Lot 1070 - Anderson Creek Academy

PROJECT TITLE:
The Winston LH

PROJECT NO: 15069AL

SHEET TITLE:
TITLE SHEET

1ST FLOOR FRAMING PLAN
COASTAL ELEVATION

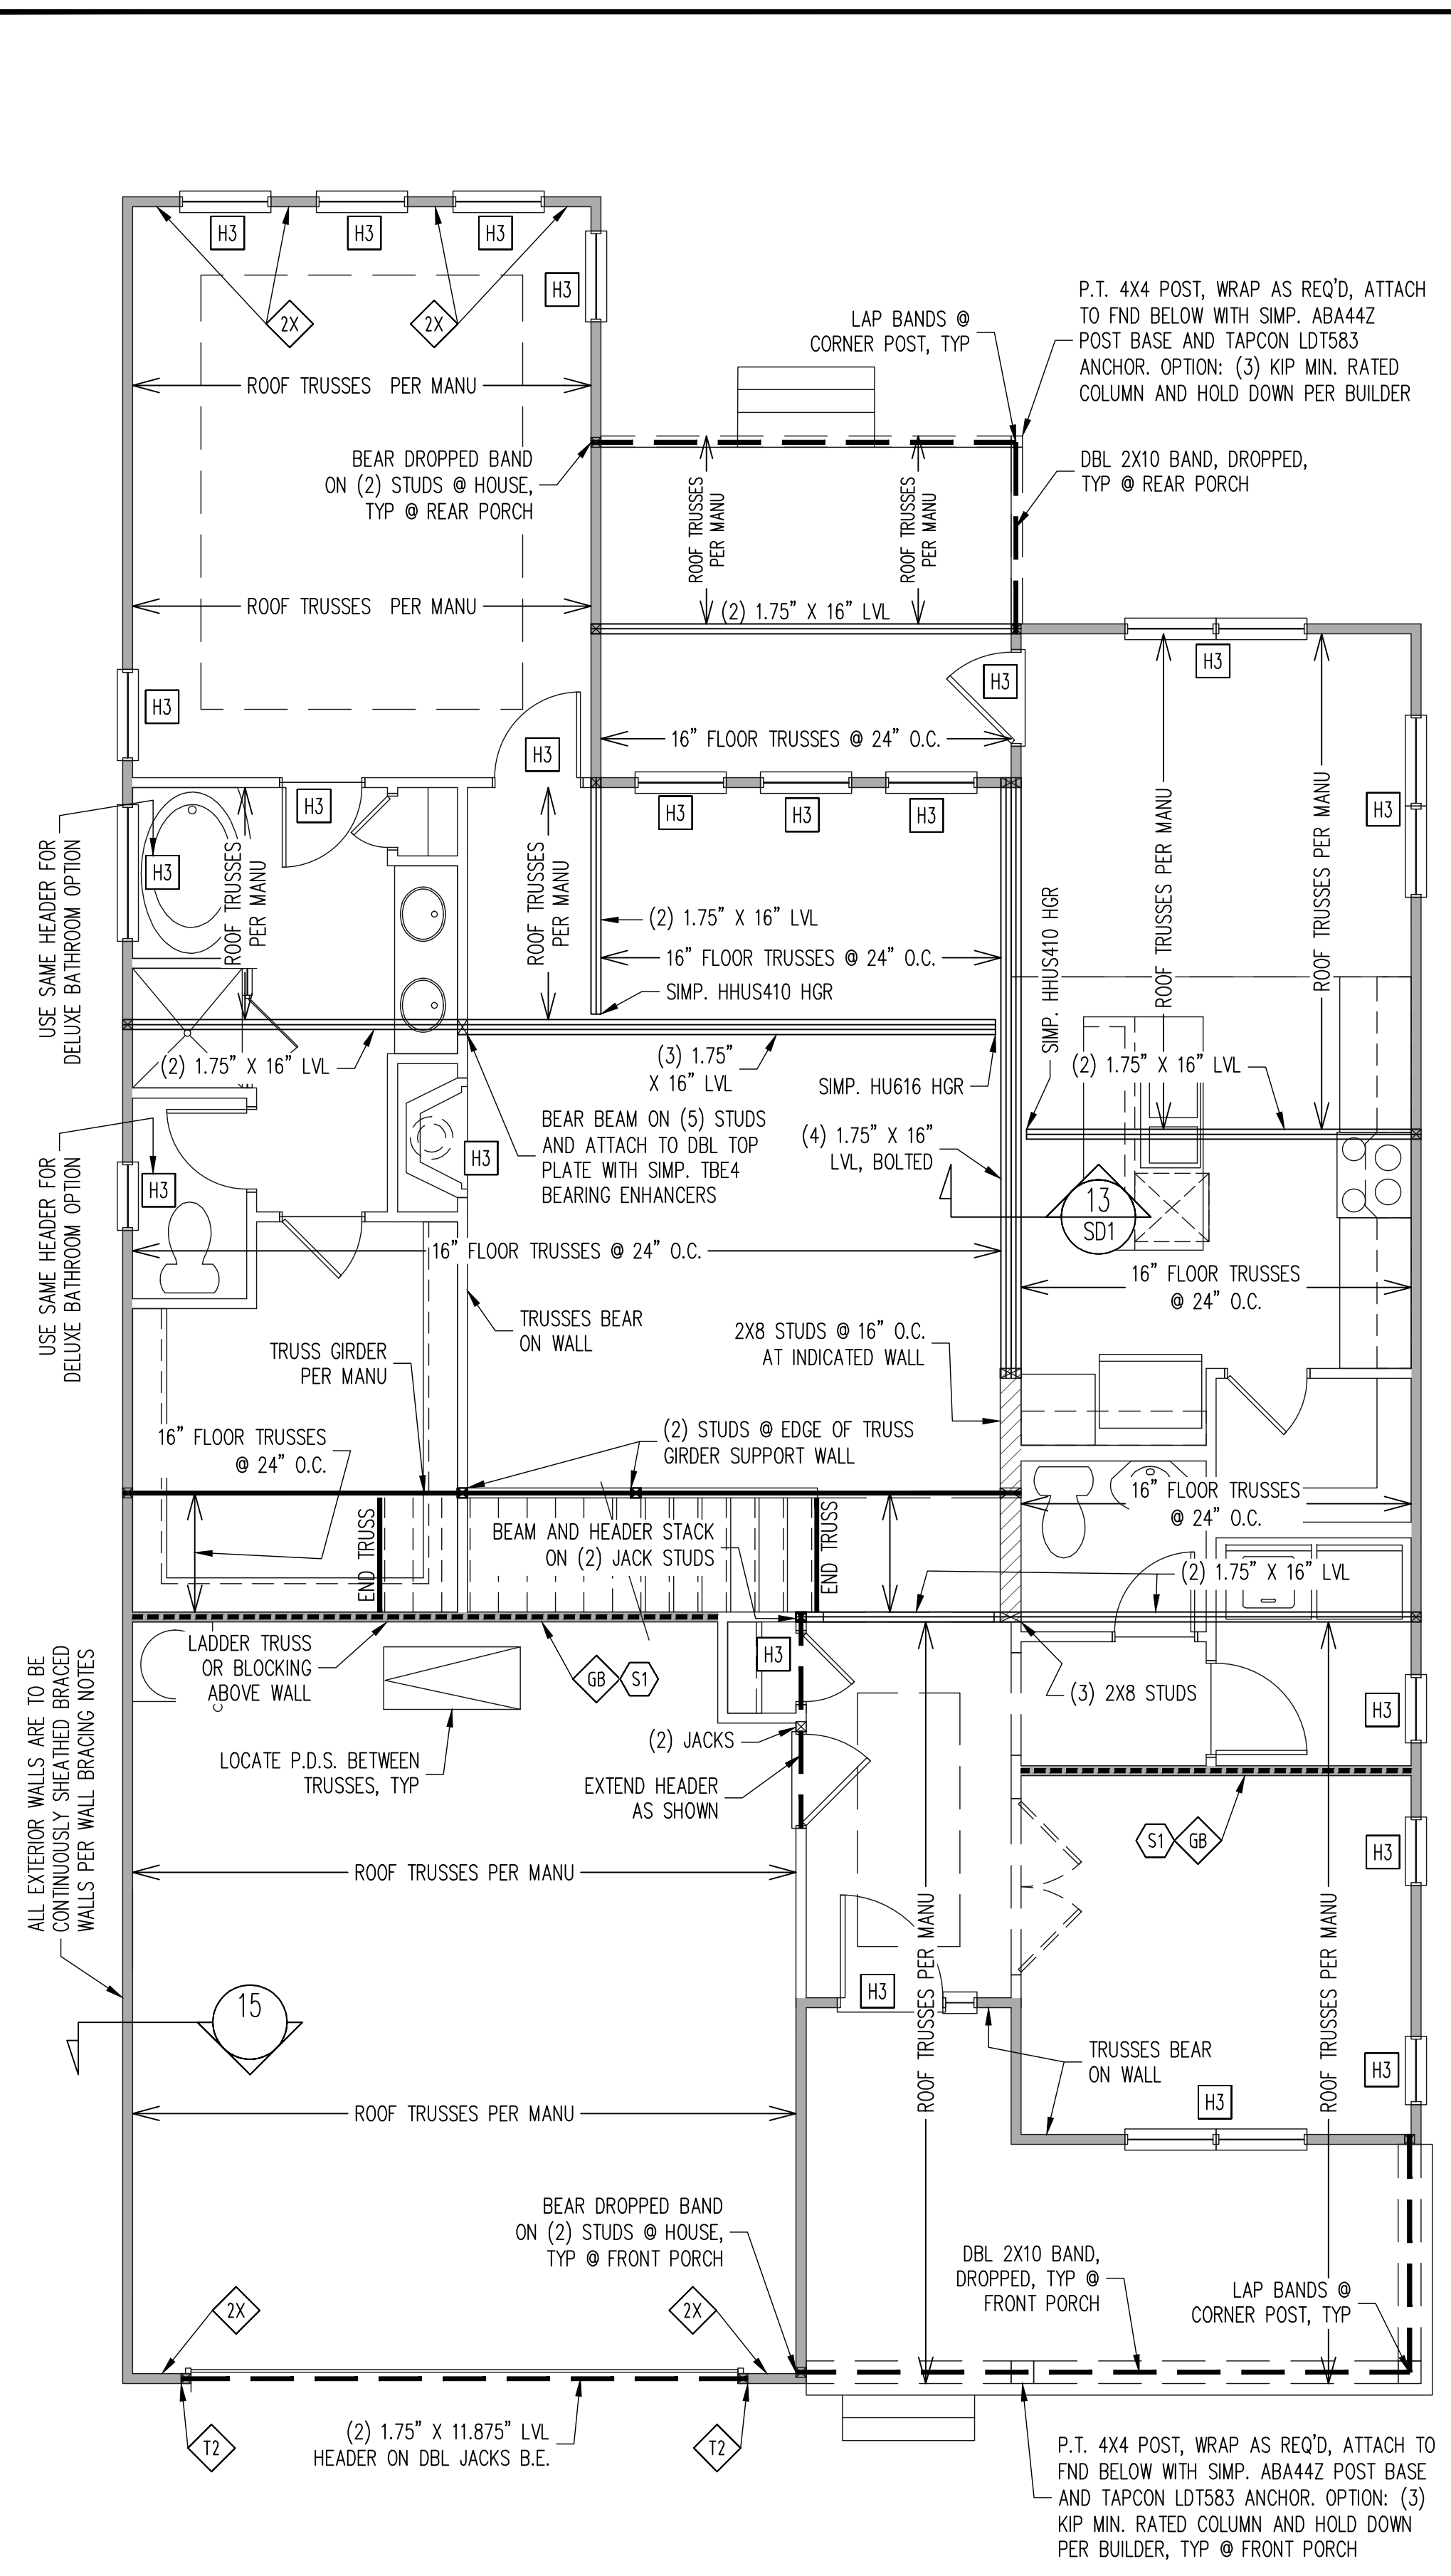
Euro
See pg S8
